**Project #22-041
Logan 1000 West Industrial
Located at 1600 South 1000 West**

REPORT SUMMARY...

<i>Project Name:</i>	Logan 1000 West Industrial
<i>Proponent / Owner:</i>	Klair Fullmer / Logan 1000 West Industrial Holdings
<i>Project Address:</i>	1600 South 1000 West
<i>Request:</i>	Design Review Permit
<i>Current Zoning:</i>	Industrial Park (IP)
<i>Type of Action:</i>	Quasi-Judicial
<i>Hearing Date</i>	July 28, 2022
<i>Submitted By:</i>	Tanya Rice, Planner II

CONCEPTUAL SITE PLAN
THIS SITE PLAN IS FOR CONCEPTUAL PLANNING.
THE SITE WILL NEED TO BE SURVEYED TO
ACCURATELY DEFINE ALL BOUNDARIES,
EASEMENTS, UTILITY EASEMENTS, RIGHT-OF-WAYS,
CONFIRM ACCESS LOCATIONS, AND WETLANDS.

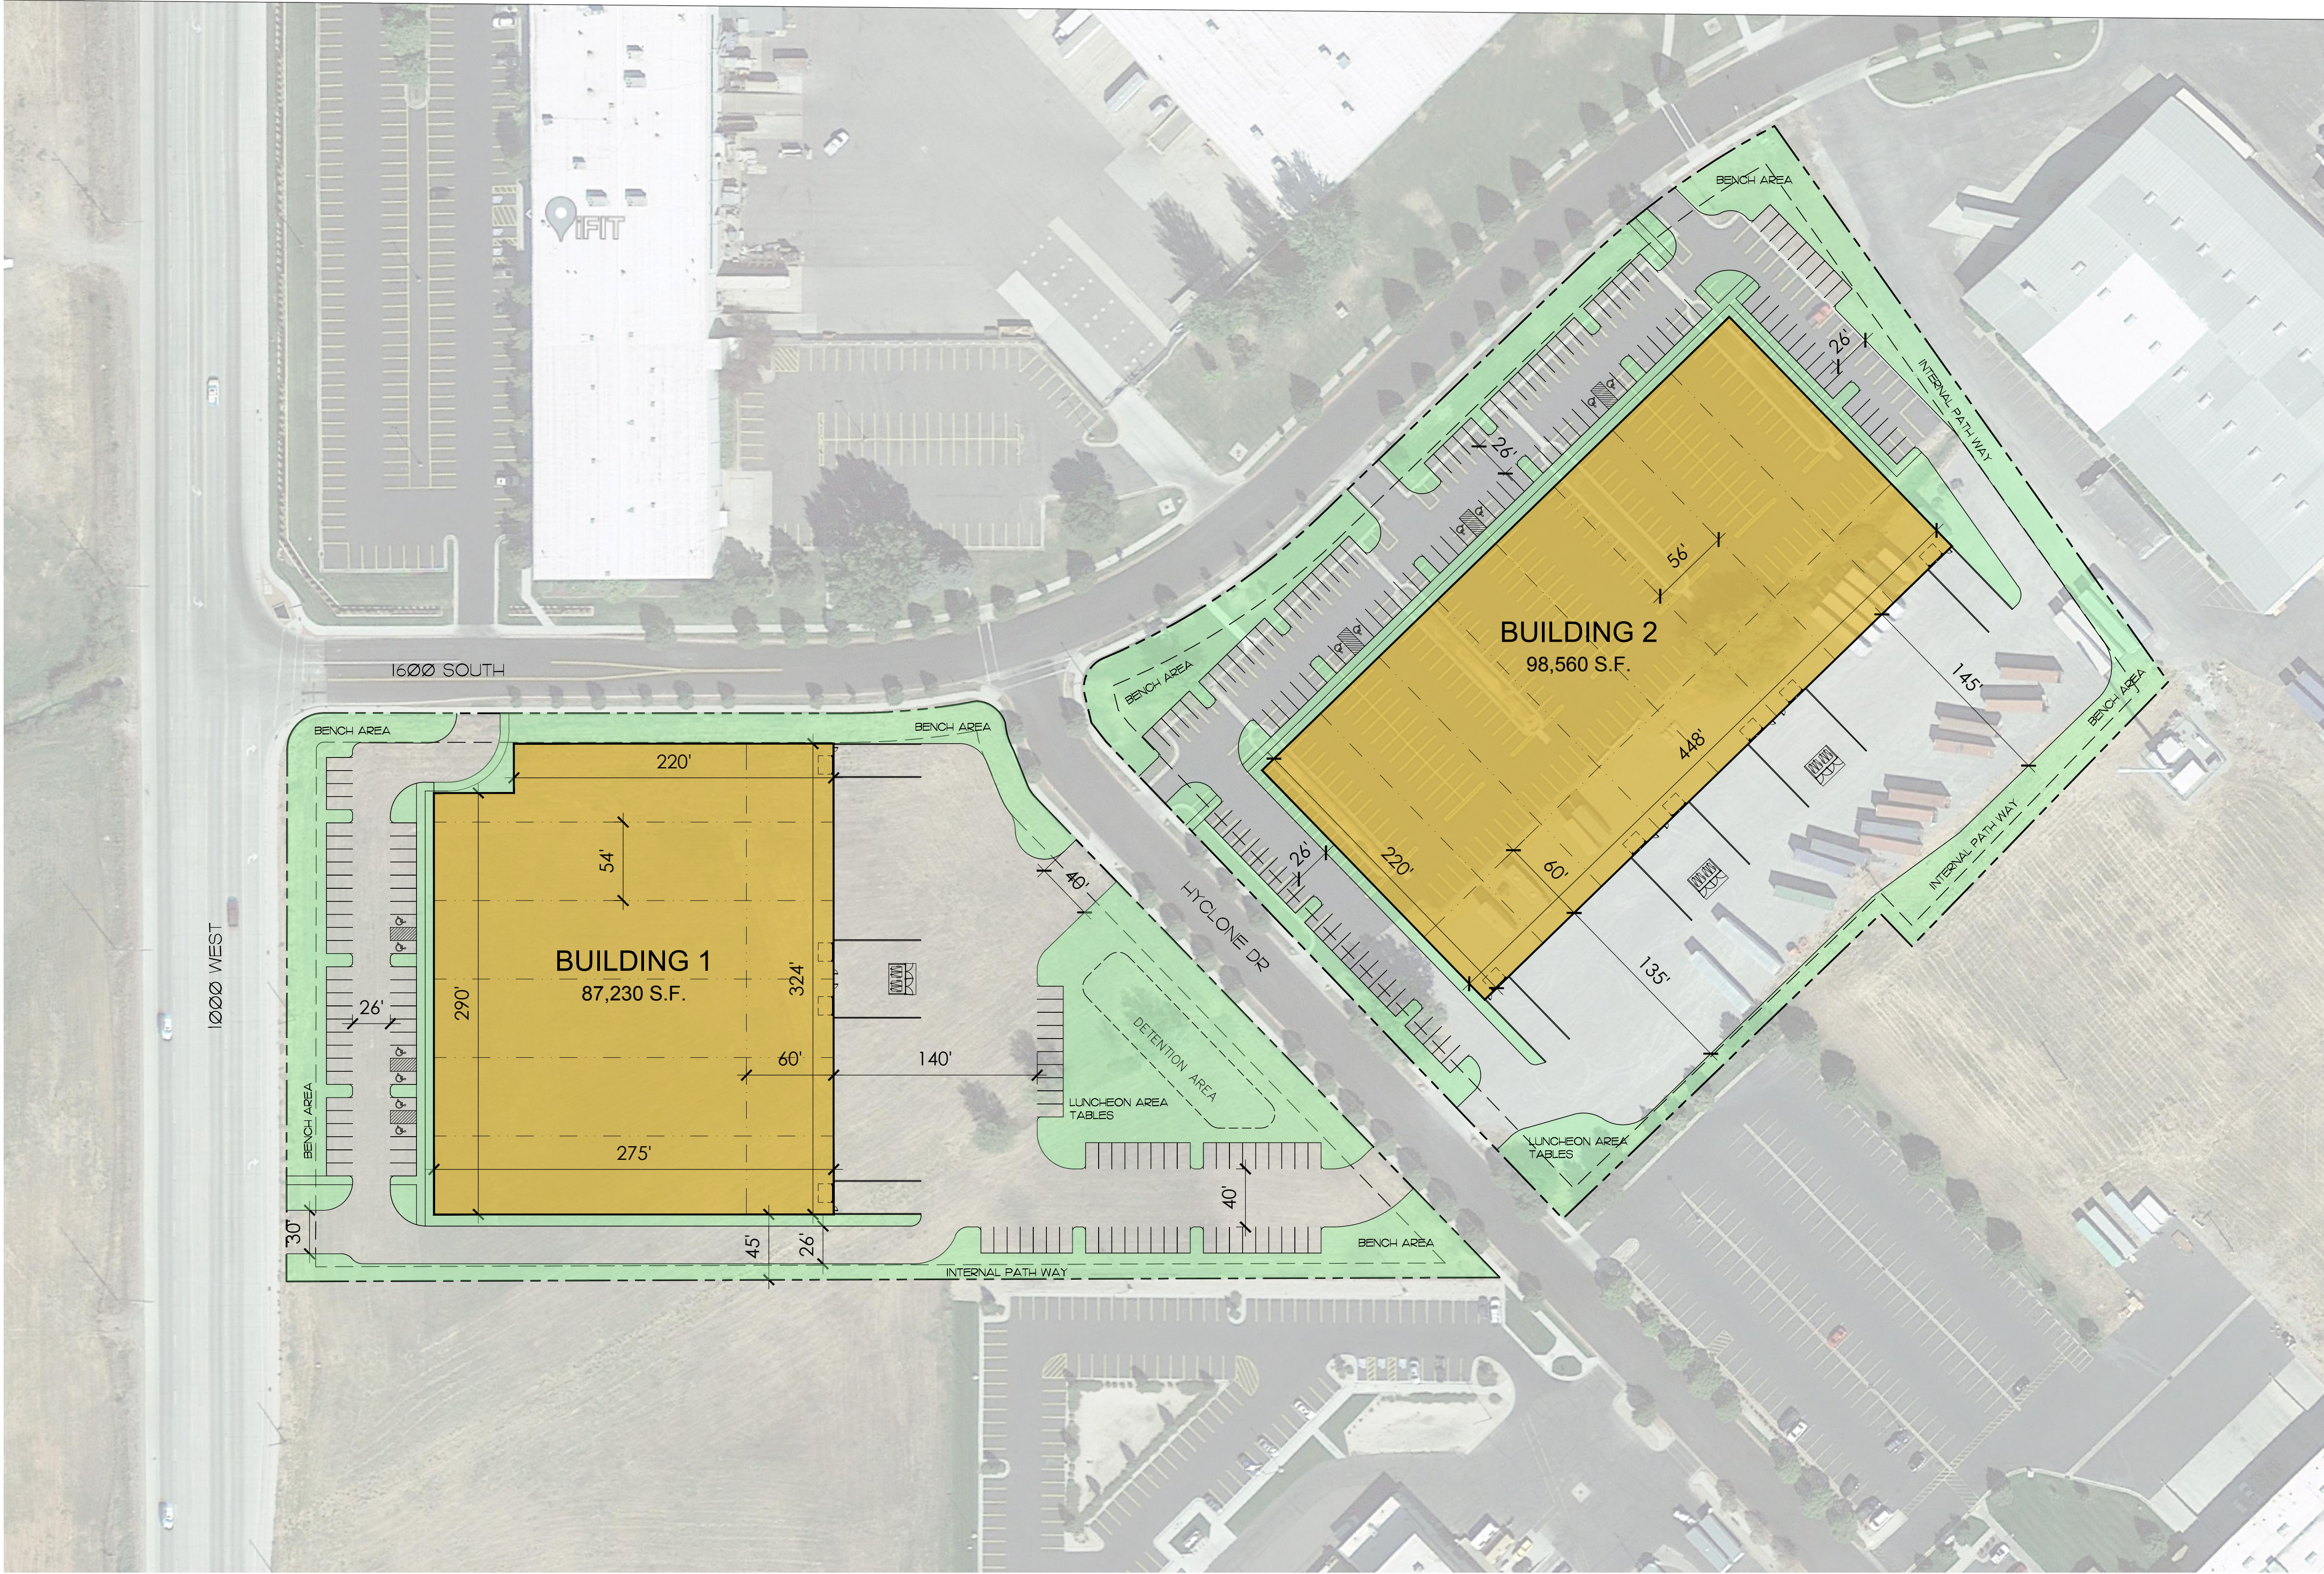
The west side parking setback for Building 2 appears to be short of the 15' requirement. As conditioned, with the west side parking setback showing 15', the project meets minimum setback requirements for the zone.

The proposed stormwater detention area is located in the rear yard of Building 1 and along Hyclone Road. Because the detention area is visually dominant along a public road, it shall be incorporated into the overall landscape design. A conceptual landscape plan has been provided and integrates the detention area with a common area. As conditioned, the stormwater detention location is in compliance with the LDC.

1. All standard conditions of approval will be recorded with the Design Review and are available in the Community Development Department.
2. The Planning Commission approves parking locations as shown.
3. The west side parking setback for Building 2 along Hyclone Road shall be 15'.

- e) Detention area shall be incorporated into the overall landscape plan.
5. All dumpsters shall be visually screened or buffered from public streets by using fencing, walls and landscaping.
